Proposal for the 03 series of amendments (Phase 3) to UN Regulation No. 129 (Enhanced Child Restraint Systems)

Submitted by the expert from France

The text reproduced below was prepared by the expert from France. It introduces the 03 series of amendments to UN Regulation No. 129 (Enhanced Child Restraint Systems (ECRS)) that were agreed upon by the experts of the Informal Working Group on Child Restraint Systems (IWG CRS) up to the last two meetings of the group. The modifications to the existing text of the UN Regulation No. 129, including ECE/TRANS/WP.29/2017/126 (Proposal for supplement 2 to the 02 series of amendments), are marked in bold for new or strikethrough for deleted characters.

Figure 2

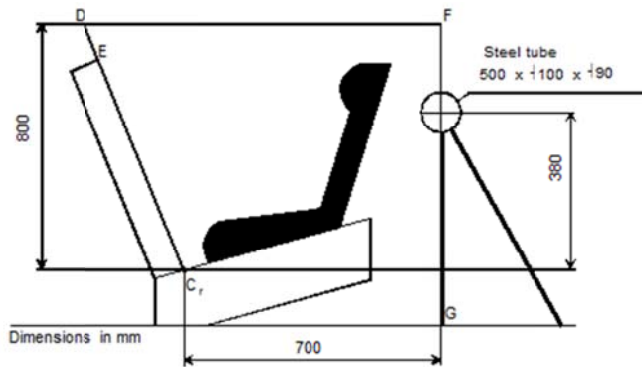
Paragraph 6.6.4.4.1.2.1., amend to read:

"6.6.4.4.1.2.1. Head excursion: no part of the head of the dummy shall pass beyond the planes FD, FG and DE, as shown in figure 2 below. This shall be judged up to 300 ms or the moment that the dummy has come to a definitive standstill whatever occurs first.

Except when testing using Q6 or Q3 dummy where the value in relation to the FD plane is 840 mm

Where a test is conducted with paragraphs 6.6.4.1.6. ~~21.1. or paragraph 6.6.4.1.6.1.2.~~ or paragraph 6.6.4.1.8.2. above, ~~only the second configuration~~ test results without 100 mm diameter bar will be considered.

Figure 4

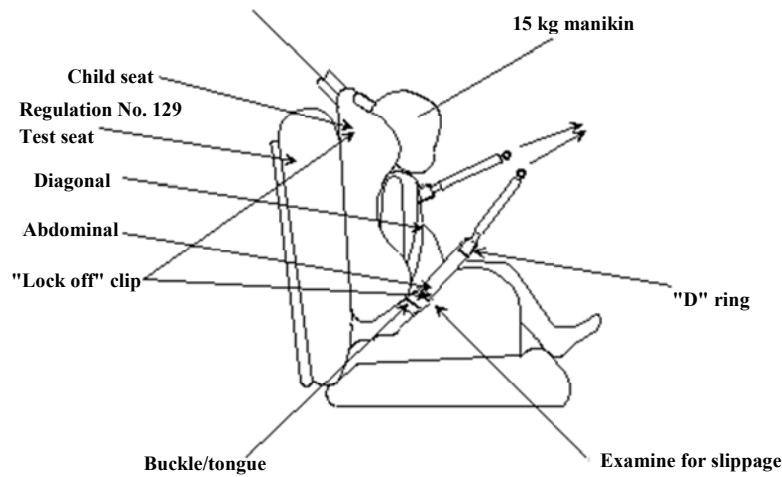
Insert new paragraphs 7.2.9. to 7.2.9.2., to read:

The Enhanced Child Restraint System and the largest manikin for which the Enhanced Child Restraint System is intended shall be set up as shown in Figure 4 below. The webbing used shall be as specified in Annex 23 to this UN Regulation. The lock-off shall be fully applied and a mark made on the belt where the belt enters the lock-off. The force gauges shall be attached to the belt via a D ring, and a force equal to twice (± 5 per cent) the mass of the heaviest dummy for the size range shall be applied for at least one second. The lower position shall be used for lock-offs in position A and the upper position for lock-offs in position B. The force shall be applied for a further nine times. A further mark shall be made on the belt where it enters the lock-off and the distance between the two marks shall be measured. During this test, the retractor shall be unlocked.

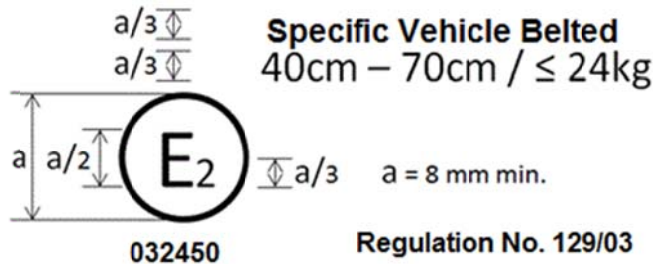
Deleted: In the figure replace i-Size universal ISOFIX by Universal Belted, delete the mass limit and replace 02 by 03¶

The Enhanced Child Restraint System bearing the above approval mark is a device not capable of being fitted in every vehicle and capable of being used for the 40 cm - 70 cm size range; it is approved in France (E 2) under the number 032450. The approval number indicates that the approval was granted in accordance with the requirements of the UN Regulation on the approval of Specific vehicle Belted Enhanced Child Restraint Systems used on-board of motor vehicles as amended by the 03 series of amendments. In addition the name of the UN Regulation must be identified on the approval mark followed by the series of amendment according to which the approval has been granted.

Figure 1
Procedure type 1

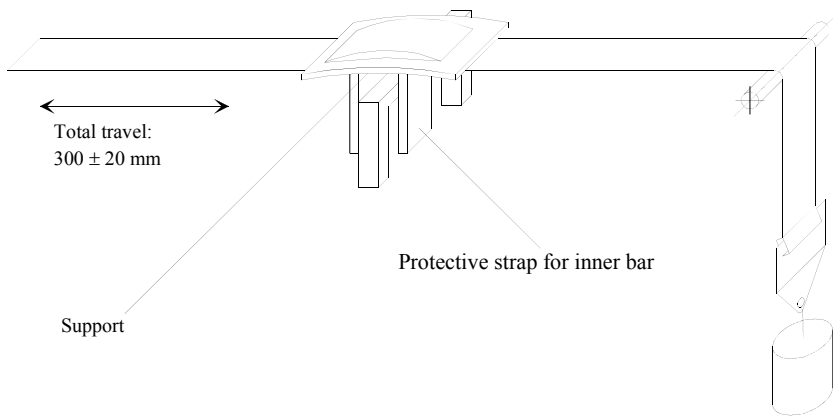
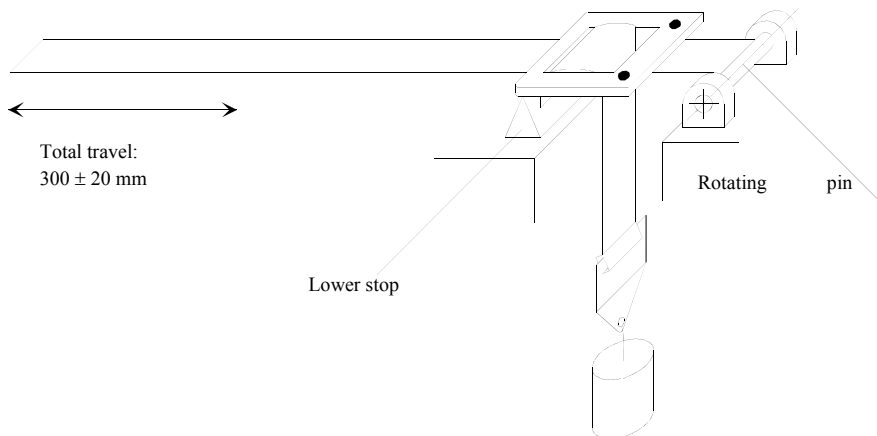
Annex 5, Figures 1 and 2, amend to read:

$F = 10 \pm 0.1 \text{ N}$, can be increased up to maximum $F = 60 \pm 0.5 \text{ N}$ (see table 8, paragraph 7.2.5.2.6.2.)

"Figure 5
Lower strap anchorages (LSA 1, LSA 2, LSA 3 and LSA 4)

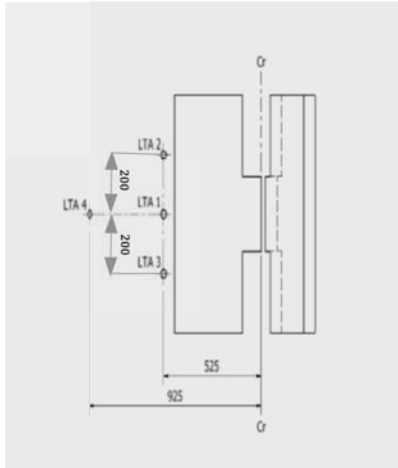
Annex 6, Appendix 2, insert new figure 5:
